SOLICITATION AMENDMENT
MODIFICATION DE L'INVITATION

Title - Sujet Baies de Lavage	
Solicitation No. - N° de l'invitation W0106-12A019/A	Amendment No. - N° modif. 004
Client Reference No. - N° de référence du client W0106-12-A019	Date 2013-01-22
GETS Reference No. - N° de référence de SEAG PW-\$QCN-015-15020	
File No. - N° de dossier QCN-2-35411 (015)	CCC No./N° CCC - FMS No./N° VME
Solicitation Closes - L'invitation prend fin at - à 02:00 PM on - le 2013-01-31	Time Zone Fuseau horaire Heure Normale du l'Est HNE
F.O.B. - F.A.B. Plant-Usine: <input type="checkbox"/> Destination: <input checked="" type="checkbox"/> Other-Autre: <input type="checkbox"/>	
Address Enquiries to: - Adresser toutes questions à: Legendre, Sylvie	Buyer Id - Id de l'acheteur qcn015
Telephone No. - N° de téléphone (418) 649-2860 ()	FAX No. - N° de FAX (418) 648-2209
Destination - of Goods, Services, and Construction: Destination - des biens, services et construction:

This amendment 004 to the request for proposal is to extend the solicitation period, amend the Statetement of Work and to answer questions from the industry.

ARCHITECTURE
PLAN DU REZ-DE-CHAUSSEE

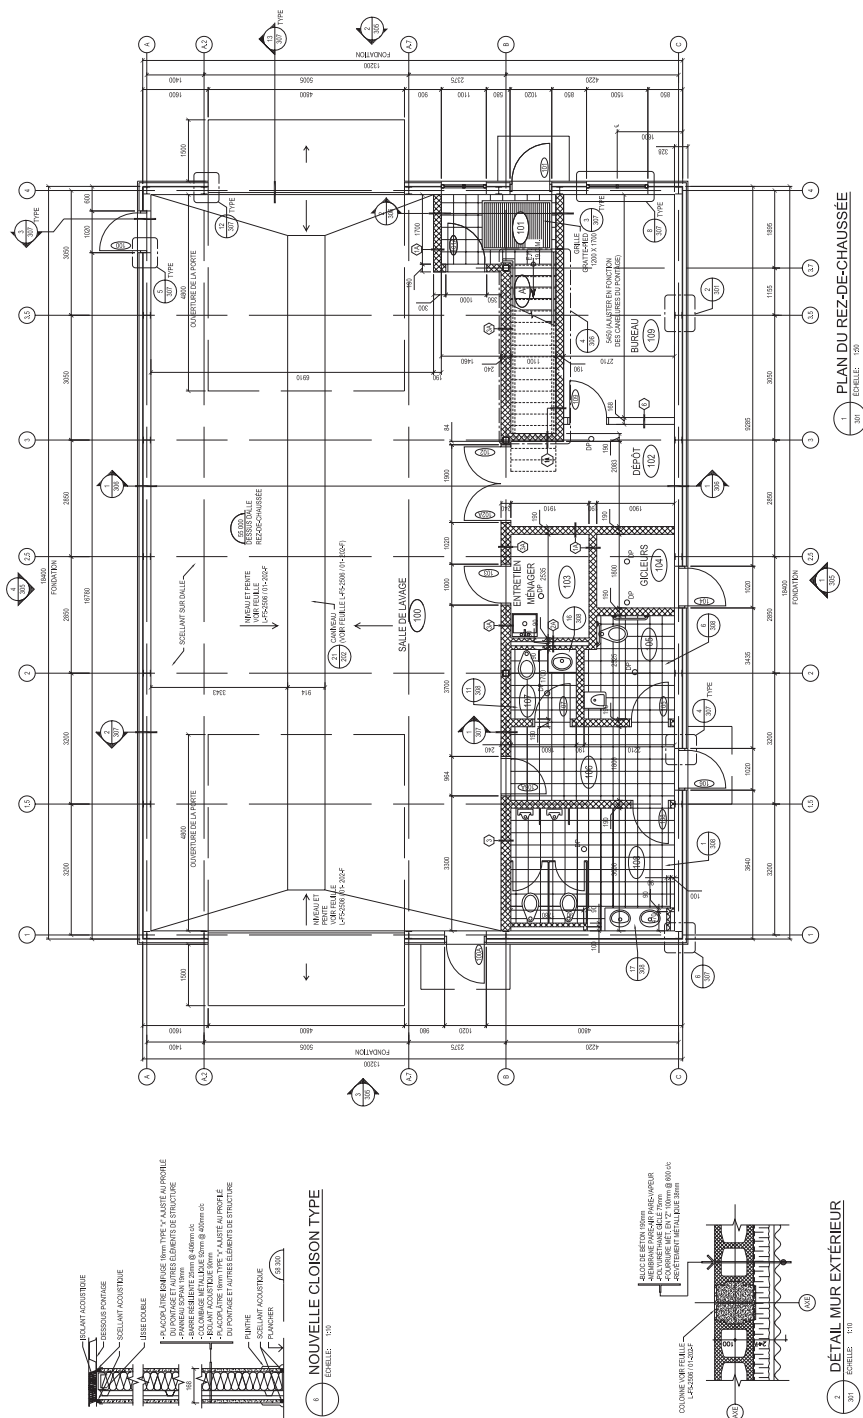
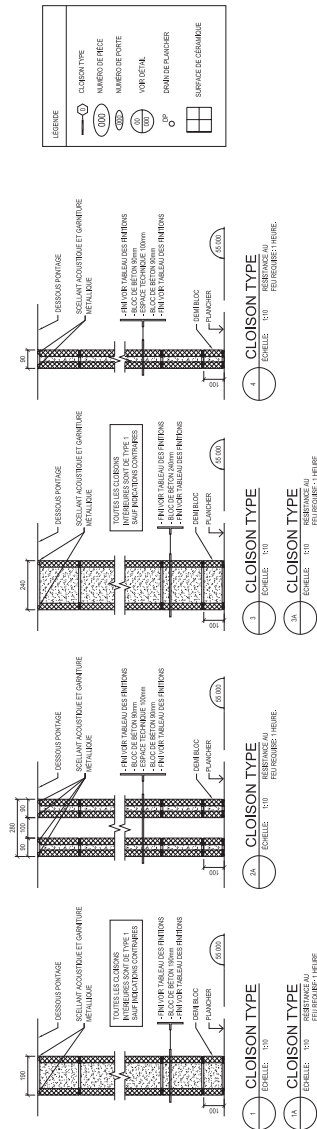
Can we get a site plan for the two locations since we couldn't come out for personal view ?

Yes, see attachments.
